Response-to-Comment to Environmental Assessment Report

Comments from Environmental Protection Department, dated 5 January 2026

Section 12A Rezoning Application for Proposed Columbarium on Various Lots in D.D. 41, Sha Tau Kok, New Territories

Environmental Assessment Report

Figure 5.1

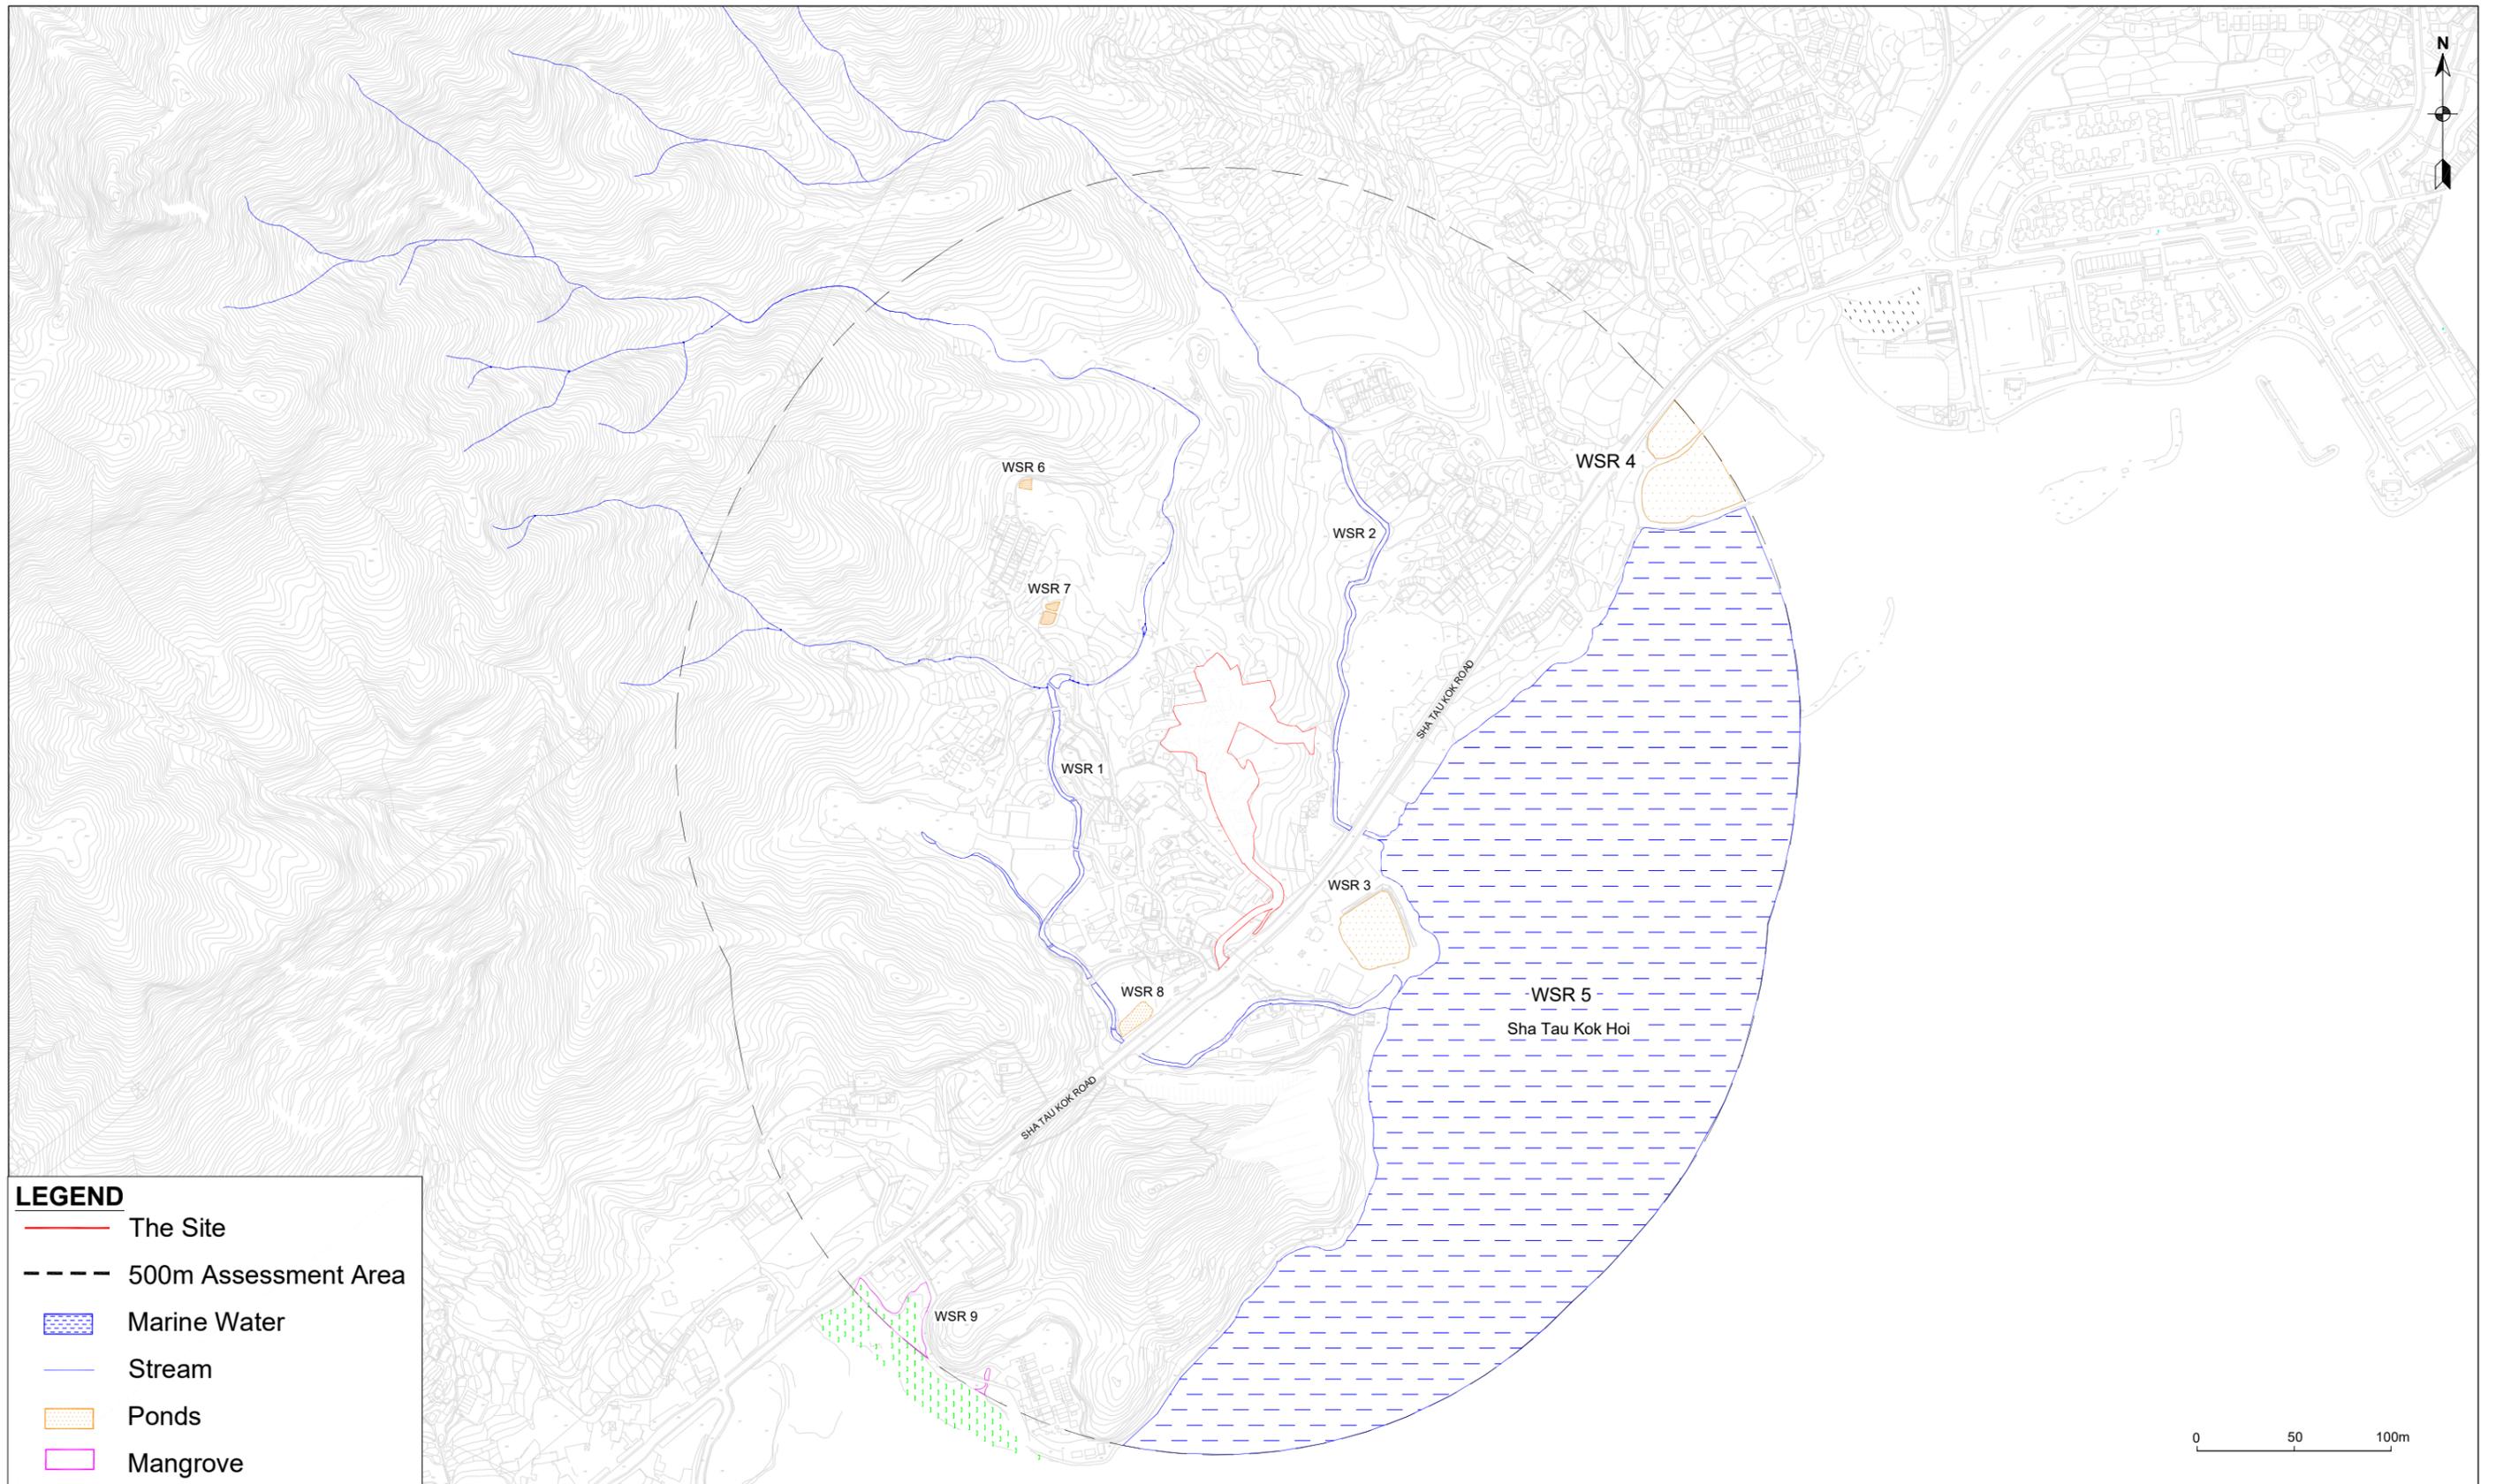
Items	Comments	Response
	- Please explain the measurement time for background noise, i.e. why there is no measurement during nighttime	during nighttime was not included in the assessment. Please refer to Section 4.4.
12	Section 4.5.3: Please explain what are the noise in multi-functions' rooms.	Noted. It is clarified that the major noise sources generated from the ceremonial rooms include musical instruments, chanting and praying associated with religious ceremony. Please refer to Section 4.5.3.
Water Quality		
13	Section 5.1: Please review if it should be Table 10(a) for discharge into inshore waters.	Noted and revised. Please refer to Section 5.1.
14	Table 5.3 & Figure 5.1: Some of the Water Sensitive Receivers (e.g., Conservation Area, mangrove and pond) included in the previous application (Y/NE-STK/4) have been excluded in the current application. Please provide justification for the exclusion	Noted and revised. Please refer to Table 5.3 and Figure 5.1.

Figure 7.1b

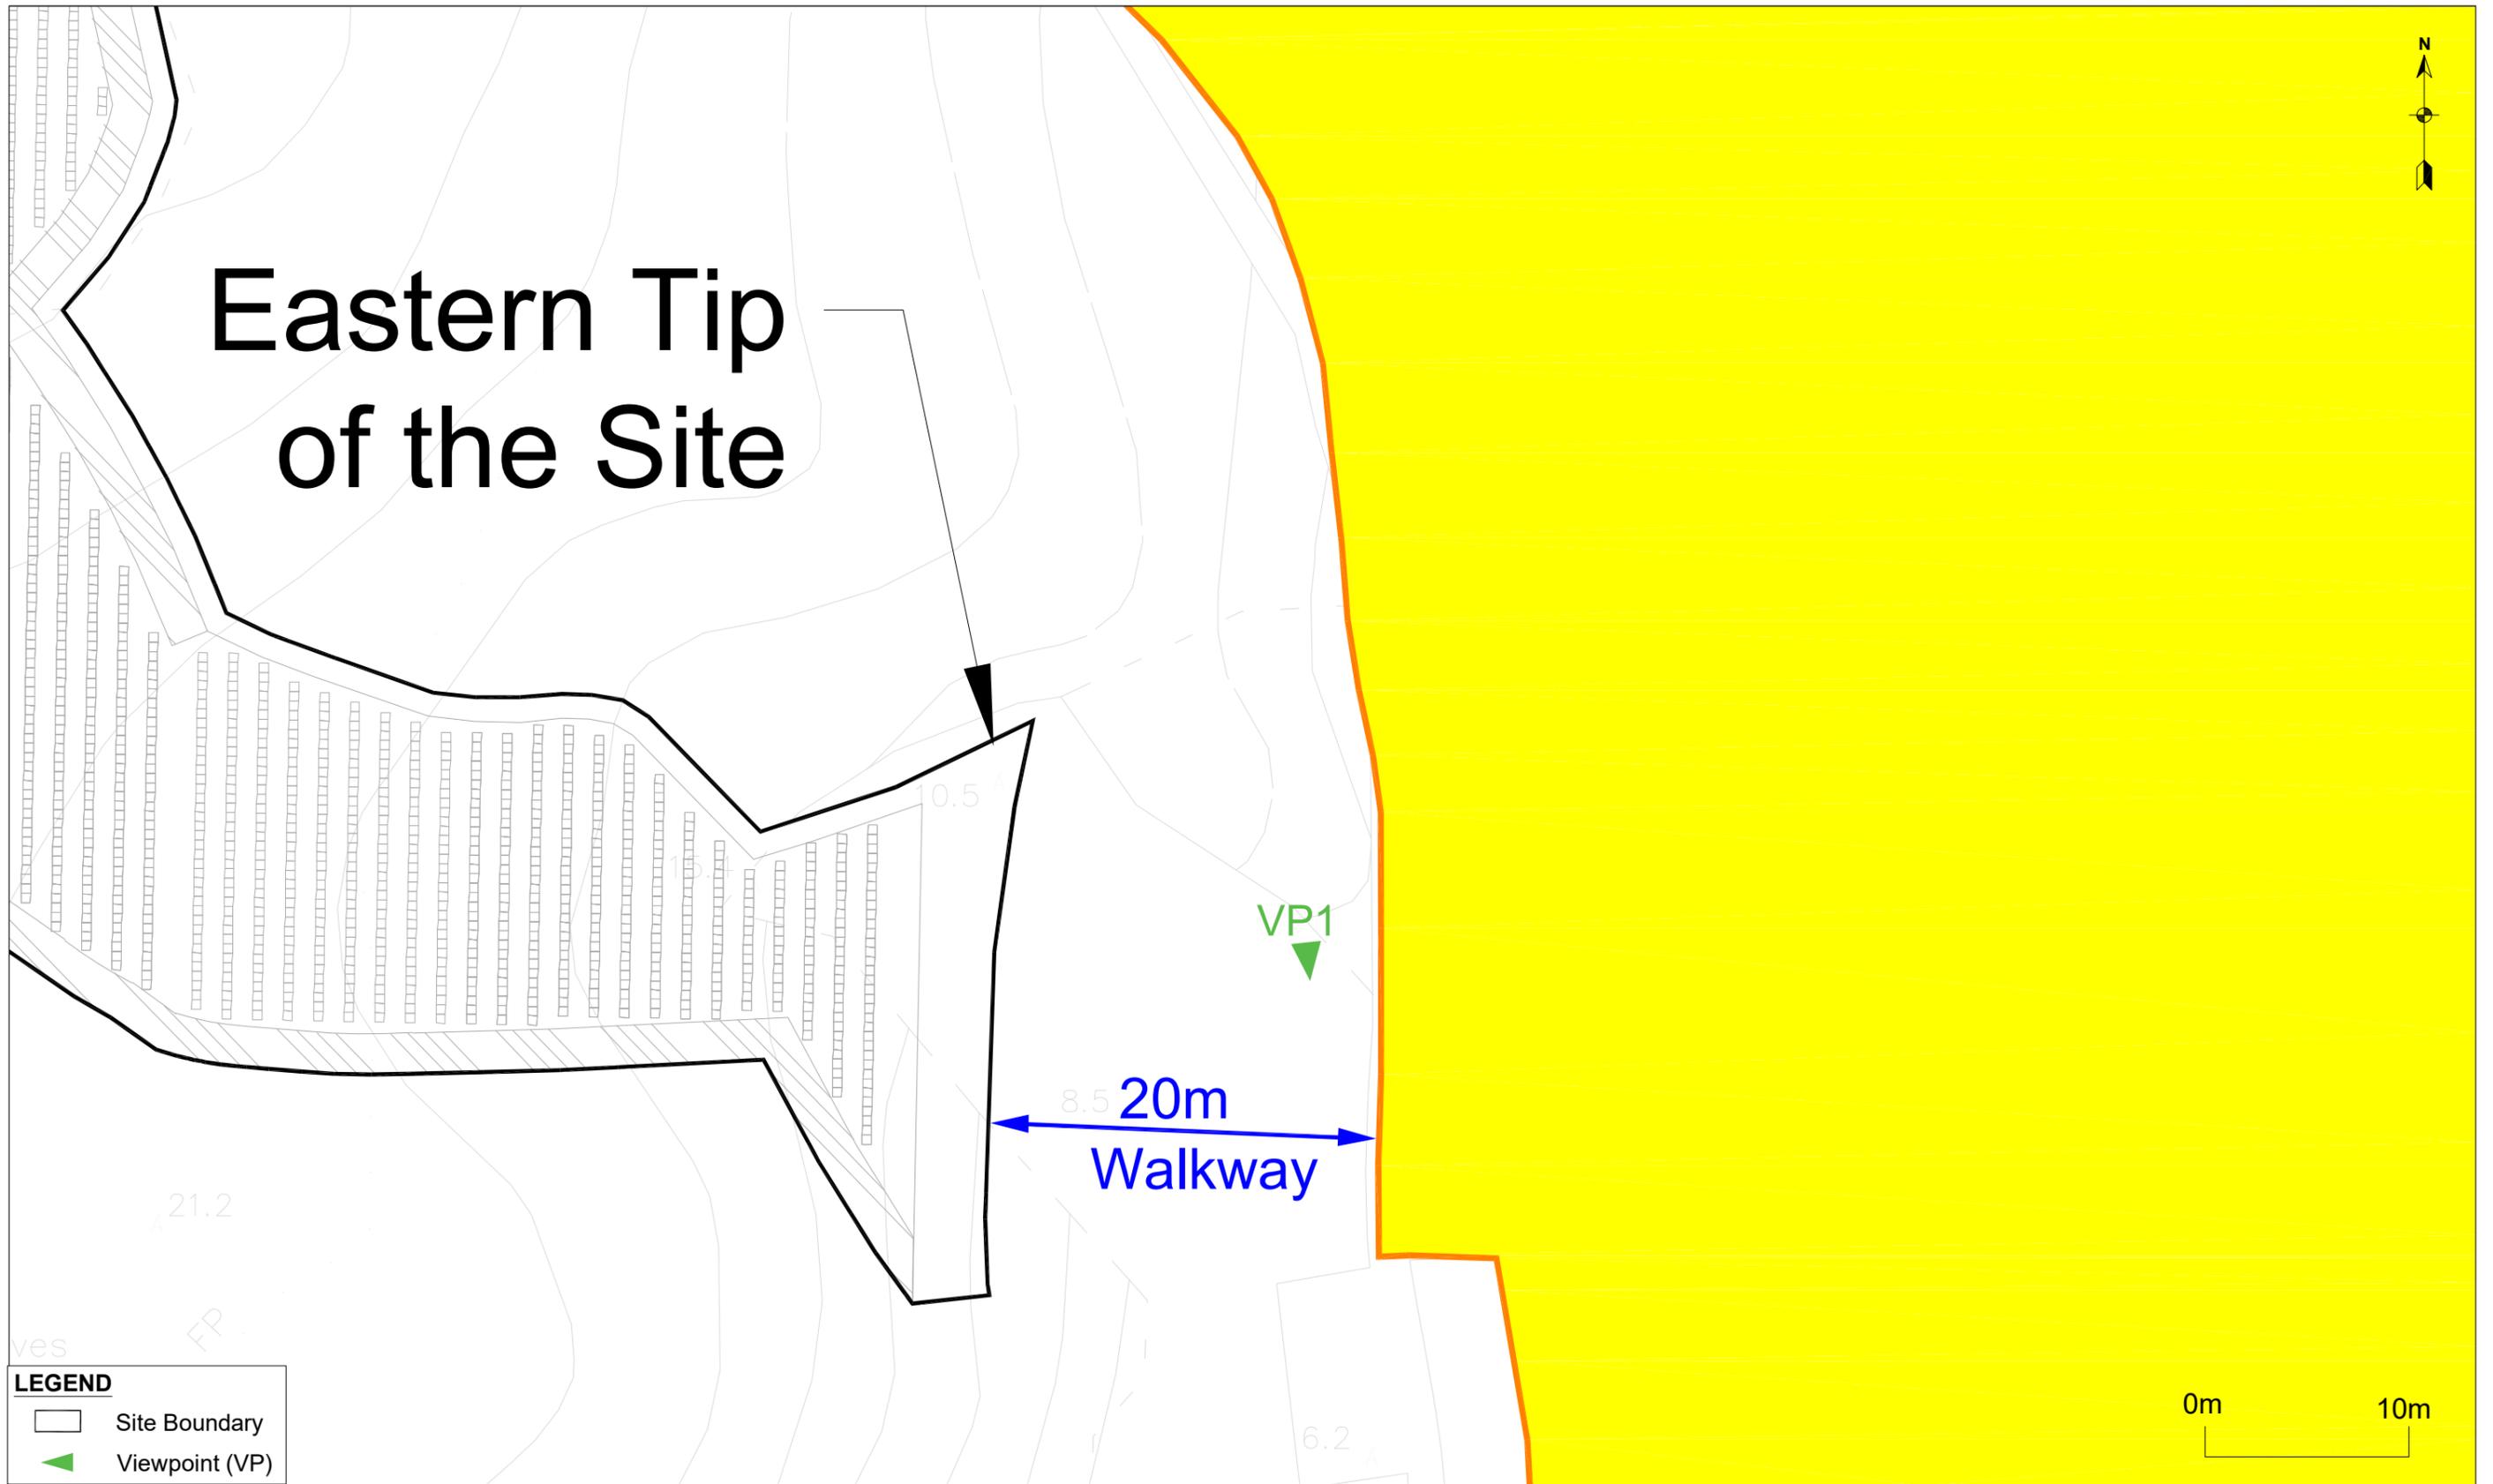
Comments	Responses
	Comments on the Environmental Assessment	-
8.	Para 8.3 – Please verify if the numbers are in line, e.g. “Outside the wall is a strip of plantation area of about 3.5m wide with 20m walkway. Therefore, the total distance between the wall and the SAI is about 20m.” Comment (6) above is relevant.	<p>The distance between the wall and the SAI is 23.5m (plantation area is outside the wall). Para. 8.3 is updated.</p> <p>The buffer between the Site and the SAI is 20m (plantation area is within the Site). Last para. of Chapter 9 is updated.</p>
